ADDENDUM NO. 7

Project Name: Sandridge Golf Club New Clubhouse

ITB Number: 2024029

1. A COMPLETE DIRECT DIGITAL ENERGY MANAGEMENT SHALL BE PROVIDED.
2. THE SYSTEM SHALL INCLUDE ALL DX EQUIPMENT.
3. THE CONTROLS CONTRACTOR SHALL PROVIDE ALL SENSORS IN ACCORDANCE TO THE CONTROLS BLOCK DIAGRAMS.

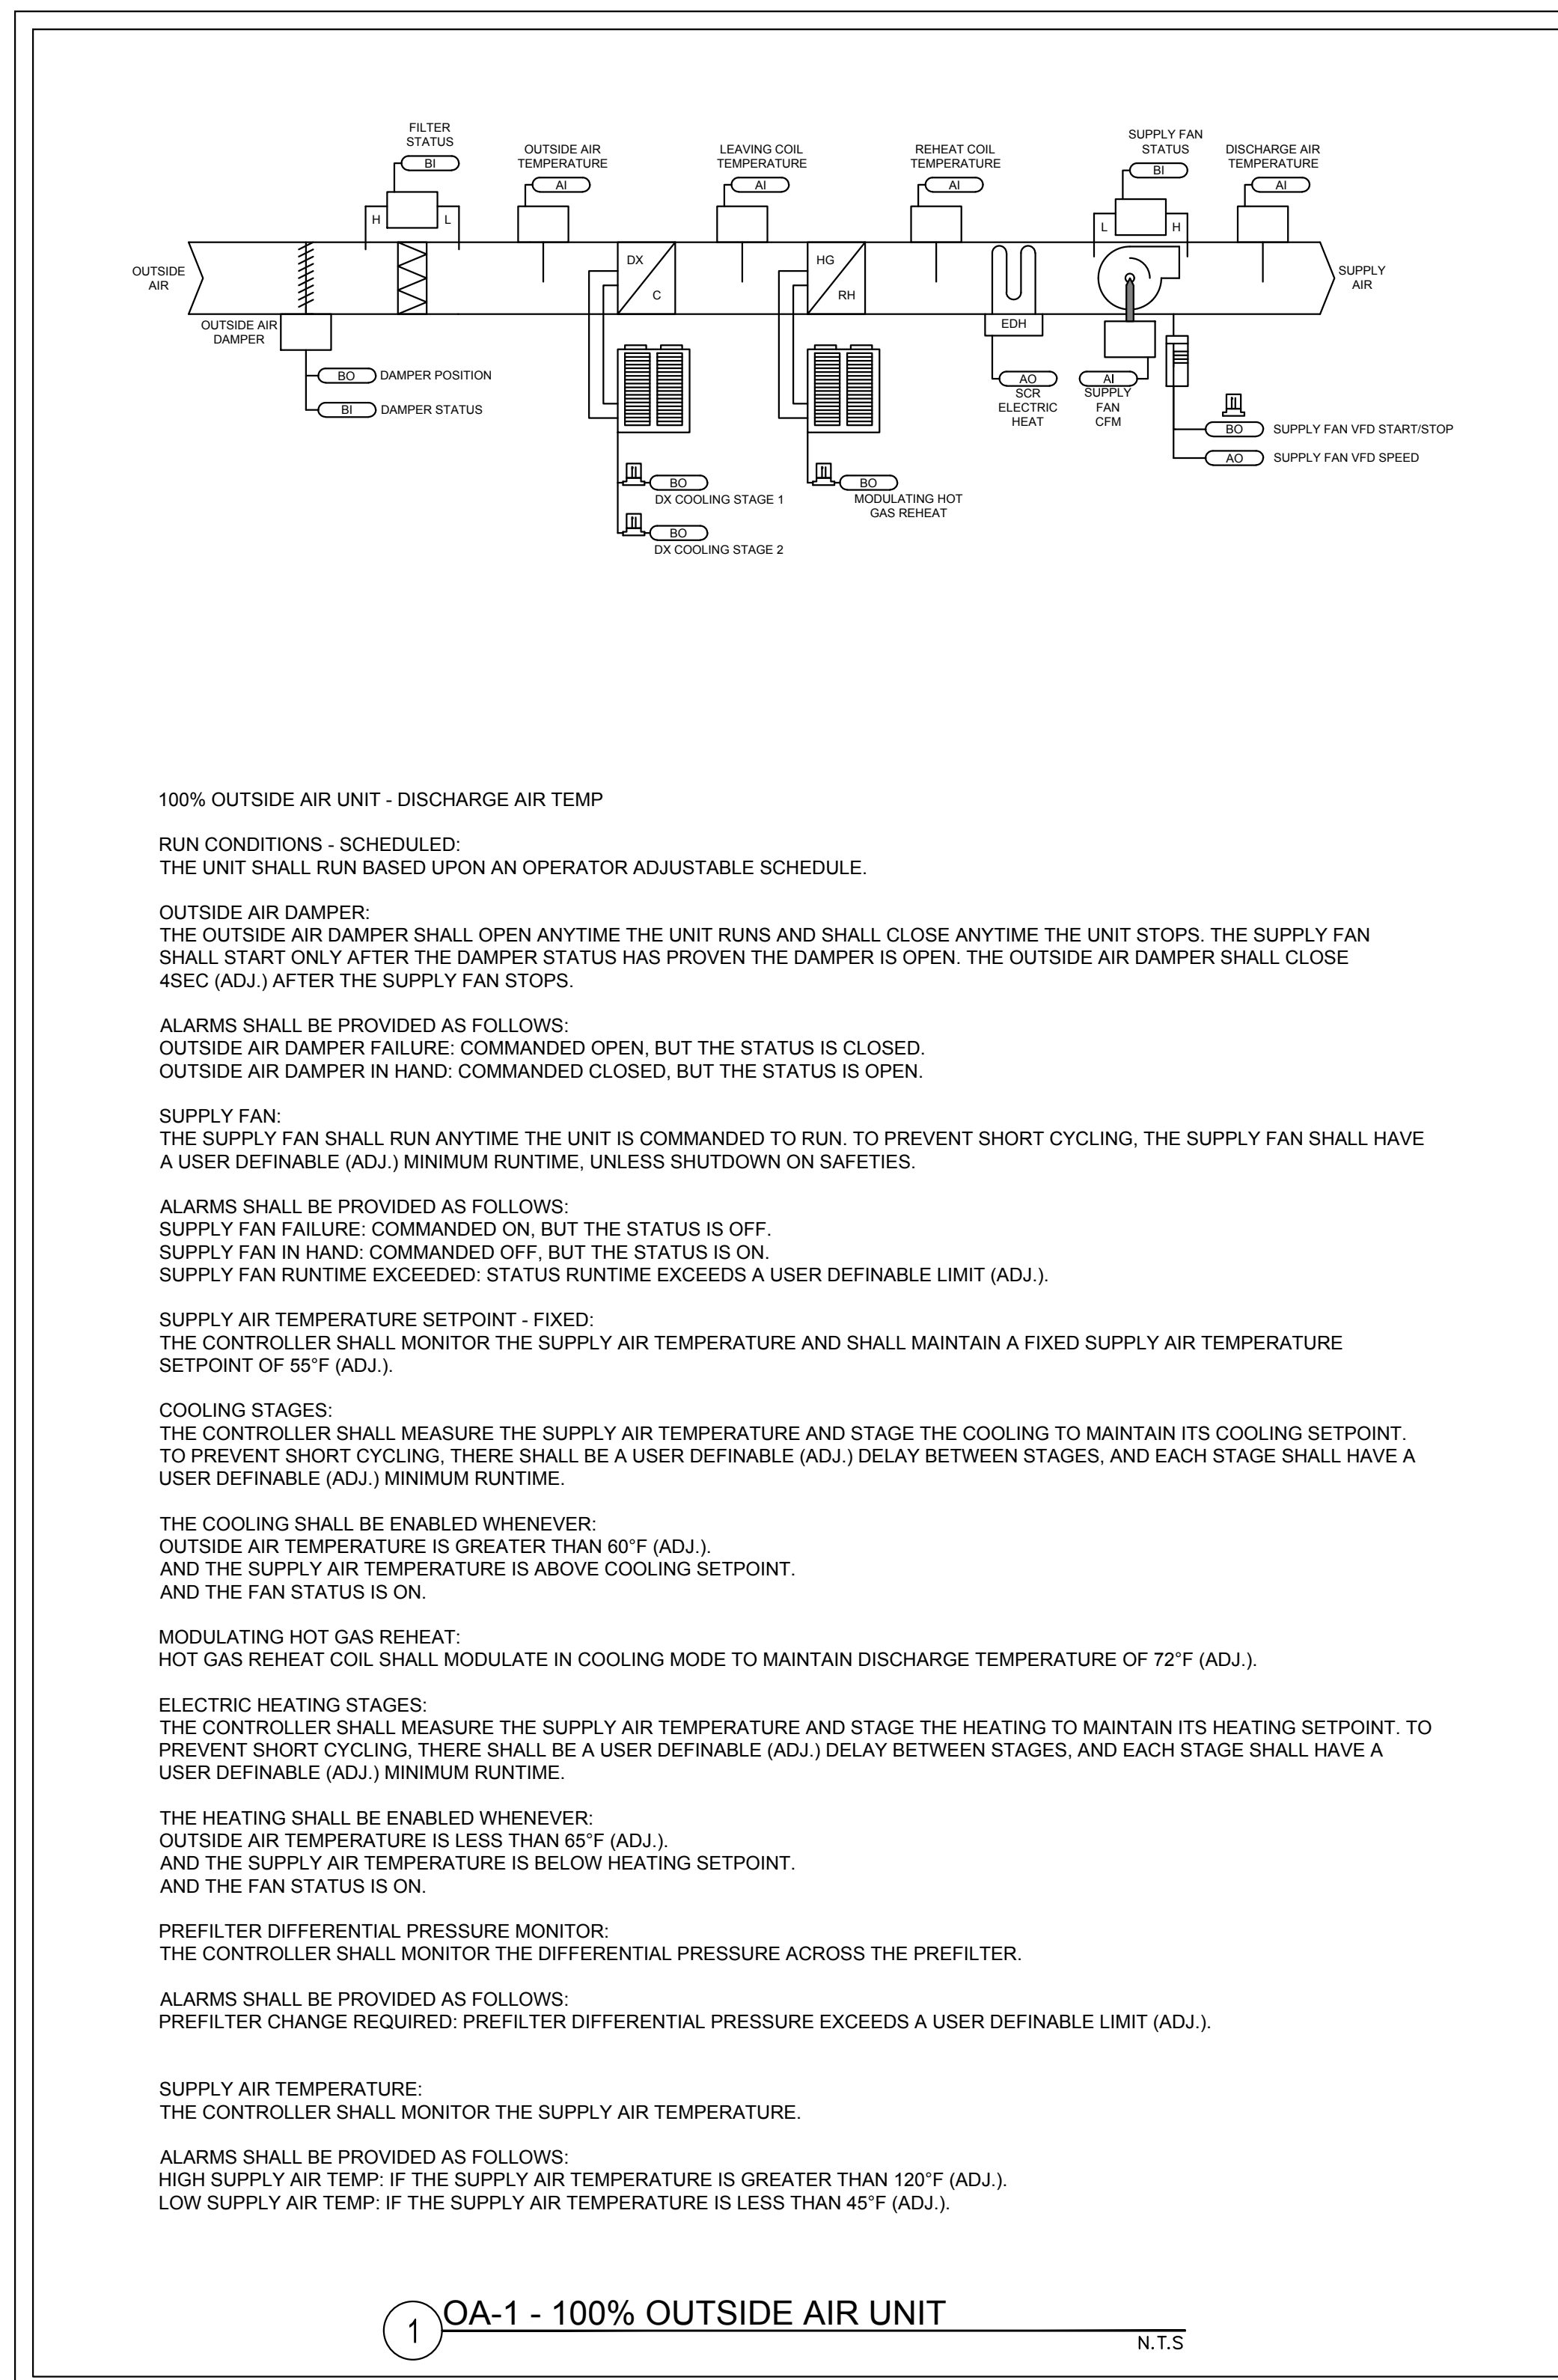
Response: Note #17 is a generic thermostat spec and has been removed for clarity
- M000 Note #20 Indicates Fully Integrated Owner/ Building Control System BMS/EMS. With interface gateways. The plans read like a standalone system, There are no control sequence plans.

5. Section 230000 Item 15 calls out controls and wiring.

6. Section 3.11 States see control drawings for control sequence. Where do I find these drawings?

Response: The building is intended to have a BMS system. Control Plans have been added to Sheet M501.
- Are you looking for a Trane tracer system with Building automation (BAS) with graphics as this also requires additional Electrical work and LAN Drops.

Response: Section 23000 was eliminated in addendum # 2. Controls sheet M501 has been added to the drawings.

Response: Controls Sheet M501 has been added to the drawings.
